1. REPORT DATE (DD-MM-YYYY) 9 Sep 2013		2. REPORT TYPE Consultative Letter		3. DATES COVERED (From – To) April 2013 – August 2013	
4. TITLE AND SUBTITLE Unshielded Facility Nondestructive Inspection (NDI) Radiation Protection Survey for Homestead ARB, FL				5a. CONTRACT NUMBER	
				5b. GRANT NUMBER	
				5c. PROGRAM ELEMENT NUMBER

13. SUPPLEMENTARY NOTES					
14. ABSTRACT Radiation protection survey of the aircraft wash-rack used for unshielded NDI operations at Homestead ARB. The NDI personnel used a Lorad LPX-160 x-ray unit for inspections. Survey was performed in accordance with T.O. 33B-1-1 and applicable Air Force standards. The aircraft wash-rack was recertified as an “unshielded facility.”

SUBJECT: Consultative Letter AFRL-SA-WP-CL-2013-0017, Unshielded Facility
Nondestructive Inspection (NDI) Radiation Protection Survey for Homestead
ARB, FL

Figure 4. Homestead Air Reserve Base Unshielded NDI Survey Map

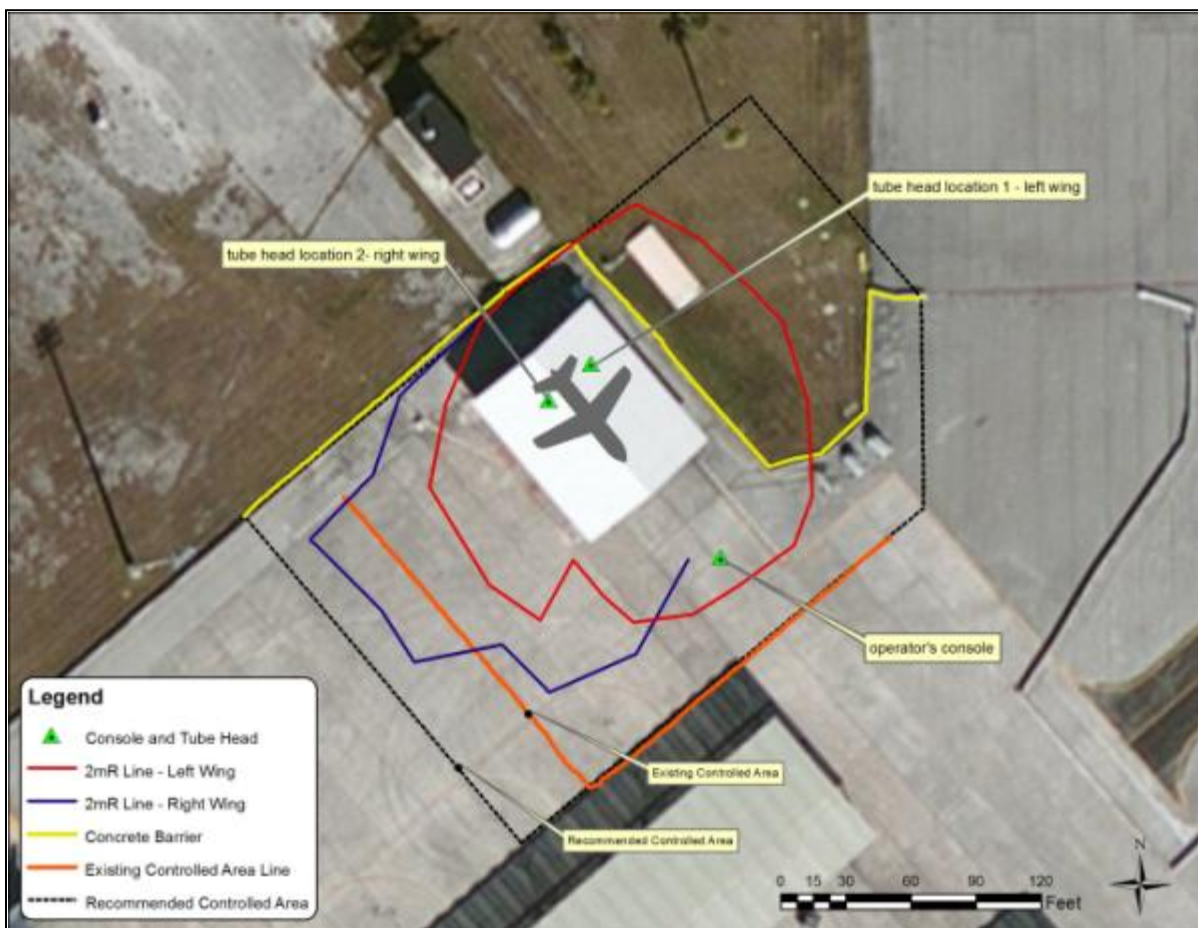
a. The radiation survey established a new recommended controlled area line as shown in Figure 4. The new recommended controlled area extends the current barrier to the southwest and southeast and establishes a new barrier line to the grass area to the northeast of the aircraft wash-rack. Measurements were taken in the area of the concrete wall to the rear of the aircraft wash-rack. The wall provides a high degree of shielding, albeit unintentional, while NDI operations are taking place. The 2-mrem/h line was found to be at the same location as the concrete jersey barriers, parallel to the rear wall, when measured from chest height. Measurements and dose estimates can be seen in Tables 1 and 2. The survey showed compliance with the occupational dose limit of 5 rem/yr and general public radiation dose limit of 100 mrem/yr. However, when measurements were taken above the height of the concrete wall, the hourly and annual dose limits were exceeded as shown in Table 2.

a. Increase and completely enclose restricted area by using additional rope barriers, cones, and signage as shown in Figure 4. It will prevent unauthorized personnel from accidentally wandering into the area where NDI operations may be taking place. Additionally, posting “Caution Radiation Area” signs on the back wall of the aircraft wash-rack during NDI operations will prevent accidental exposure to personnel who may be unaware of ongoing NDI operations. Refer to T.O. 33B-1-1, para 6.8.8.2 for guidance.
